Committee of Experts on the Transport of Dangerous Goods and on the Globally Harmonized System of Classification and Labelling of Chemicals

Amendments to the classification of desensitized explosives according to the GHS

Transmitted by the experts from Germany and the United States of
America*

Proposed amendments to Chapter 2.17 of the GHS and Section 51 of the Manual of Tests and Criteria

Decision logic 2.17.1 for desensitized explosives

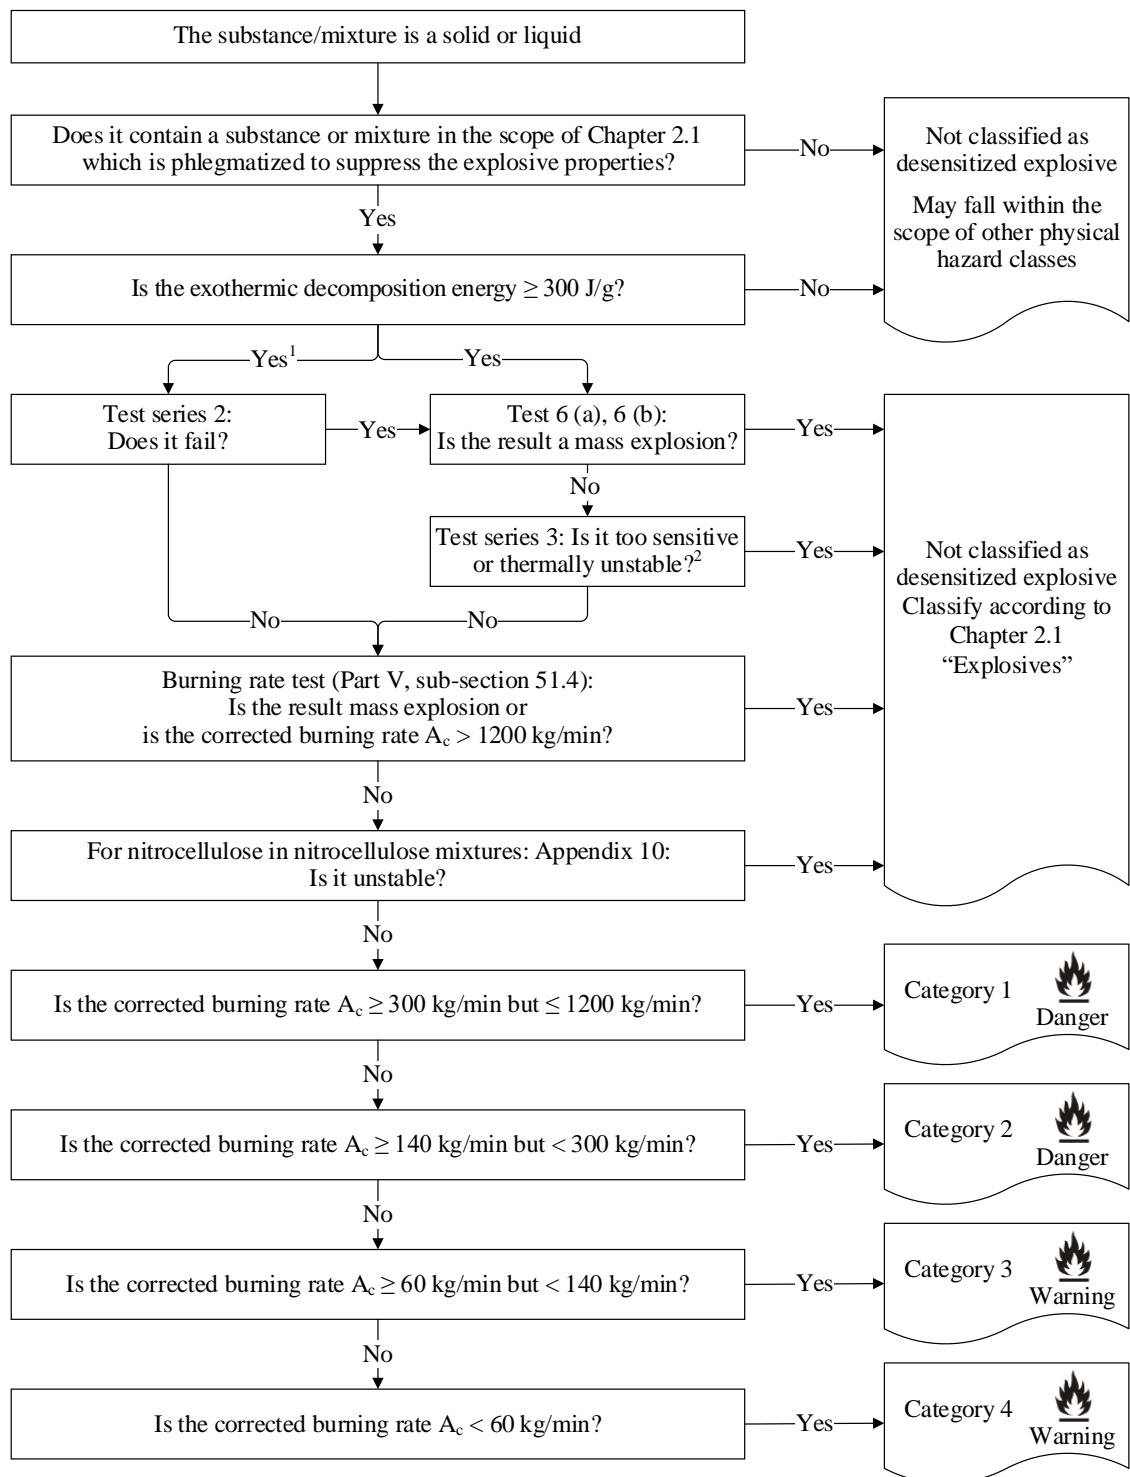
Decision logic 2.17.1 Replace with the following:

Insert the following footnotes:

¹ Test series 2 is optional. The alternative route (via test 6 (a) and (b) and test series 3) may be taken directly without performing test series 2.

² Test series 3 is not applicable to nitrocellulose mixtures containing no other explosives than nitrocellulose.
